Subject: **THIRD RESPONSE TO PEER REVIEW**
Phase 2 of Tentative Tract 37-46
White Mountain Estates Subdivision
Chalfant Valley, Mono County, California

Reference: Review of Revised Site Geologic Map
Phase 2 of Tentative Tract Map No. 37-46
White Mountain Estates Subdivision
Chalfant Valley, Mono County, California
Prepared by AMEC Earth & Environmental dated June 13, 2006

PROJECT: GEOLOGIC LOG OF TRENCH T-12 PHASE 2 OF WHITE MOUNTAIN ESTATES SUBDIVISION				
HORIZ. SCALE: 1"=5'	VERT. SCALE: 1"=5'	DATE: 8/16/2006		
DRAWING: 3.30559_TRENCHES.DWG	LOGGED BY: HDD/RWS	DRAFTED BY: HDD/RWS		
JOB NO.: 3.30559	TITLE: SHEET 6 OF 6

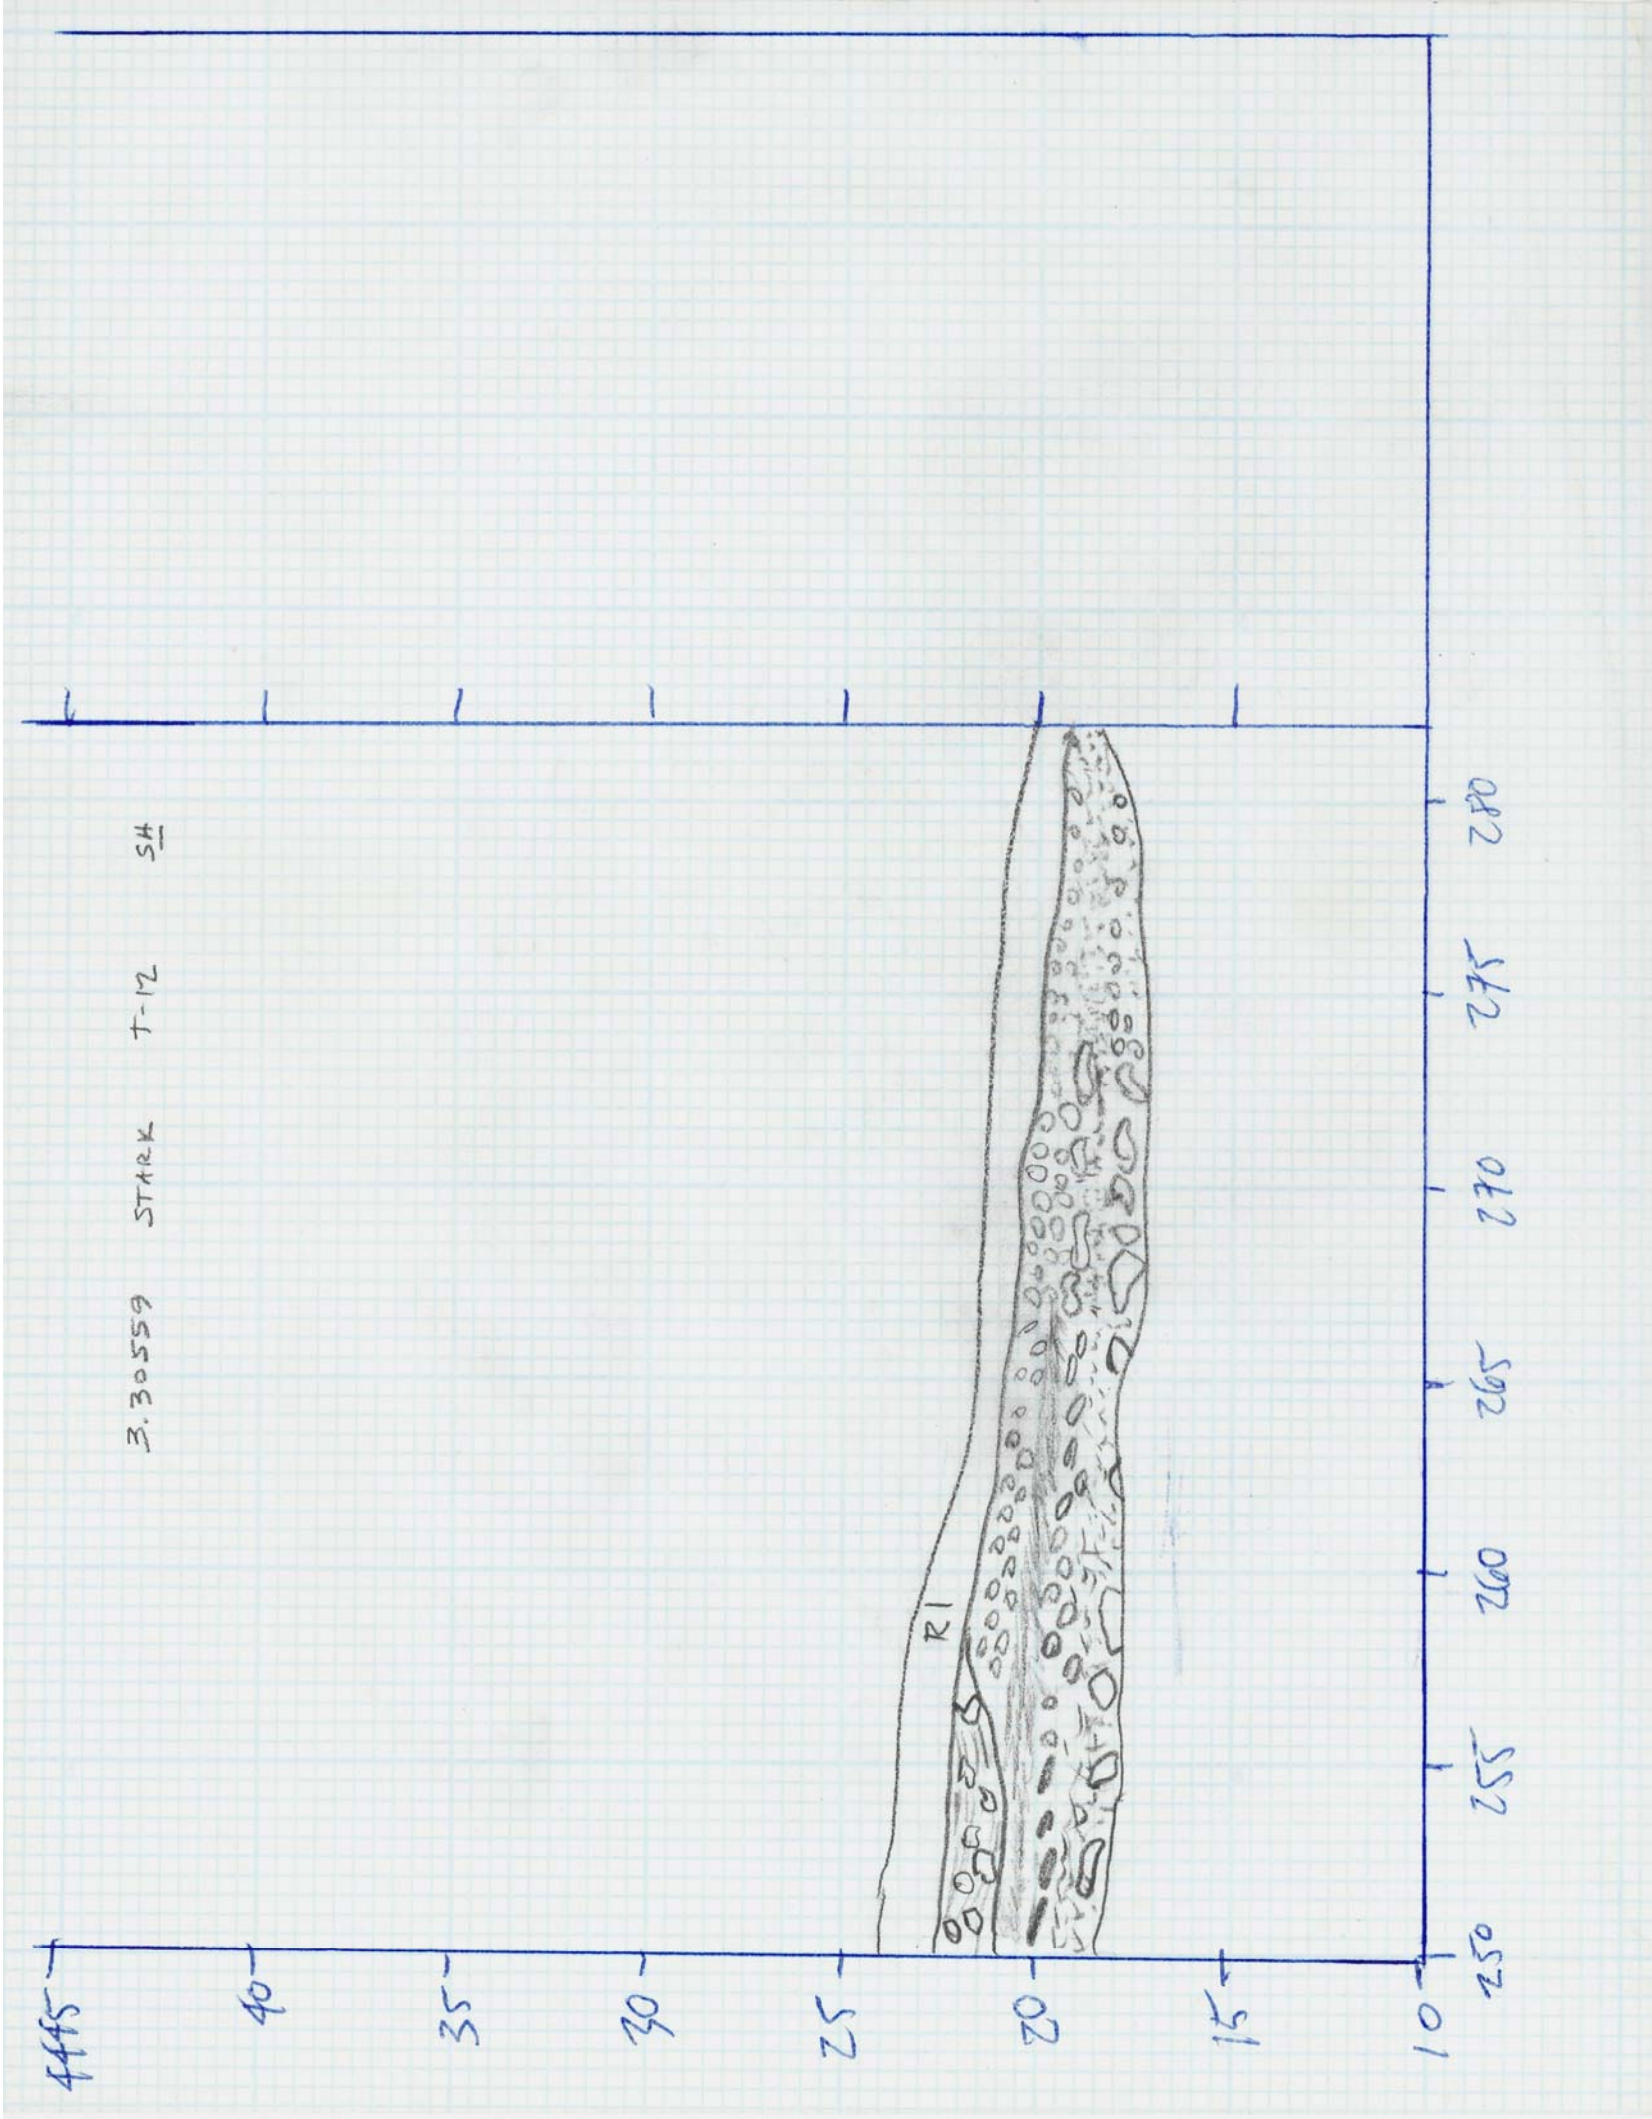
Due to the uncertainty associated with the location or projection of active fault features from the existing exploratory fault trenches it is recommended that Minimum building areas be established for each lot within the existing habitable zones. Building areas that can be established immediately adjacent the existing fault trench excavations are approved with respect to active faulting based on the existing data. Proposed building areas that are more than 50 feet from an existing fault trench will require additional subsurface fault trenching to establish that the building area is free of active faulting. The location of any proposed additional fault trenches, to substantiate the validity of a proposed building area, should be reviewed and approved by the geotechnical consultant for Mono County prior to excavation and logging. The designation of acceptable building areas, verified by the existing fault trench data or new fault data as discussed above, should be accomplished prior to Mono County's approval of the tract.

Response: Two additional fault trenches were proposed and located upon approval via telephone and email from the geotechnical consultant (AMEC) for Mono County. Each trench was located to provide additional data within those habitable areas that had been previously established by rather lengthy projections. Additional Fault Trench T-11 was excavated and logged across the habitable zone that traverses proposed Lot 43, and additional Fault Trench T-12 was excavated and logged across the habitable zone that traverses proposed Lot 41. Each trench exposed faulting OUTSIDE of each habitable

zone as was anticipated from our previous findings. Faulting was NOT observed within either habitable zone on either lot. Therefore, we have revised each habitable zone to reflect these findings, and they are shown on the attached Revised Site Geologic Map. Based on the dimensions of the largest footprint of the manufactured homes that are proposed for the subject site, Minimum Building Areas (MBA) have also been established for each lot within each revised habitable zone. It should be noted that each MBA location is provided to demonstrate fit and buildability within the habitable zone only; they are not intended to restrict structures to that location or dimension. The west side of the habitable zone across Lots 40 and 42 has been revised such it is now setback fifty feet from the nearest mapped fault to the west, and as a result the MBA on Lot 42 has been repositioned inside the habitable zone such that there is still adequate room for a habitable structure. Additionally, the habitable zone has been removed from proposed Lot B Common Area for Phase 1 of Tentative Tract 37-46 since the proposed water storage tank and propane tanks are not habitable structures; however, their proposed locations have been plotted such that they are as far away as possible from the nearest mapped faulting on this lot in order to minimize the potential for disruption or damage to the tanks from future ground surface rupture-causing events.
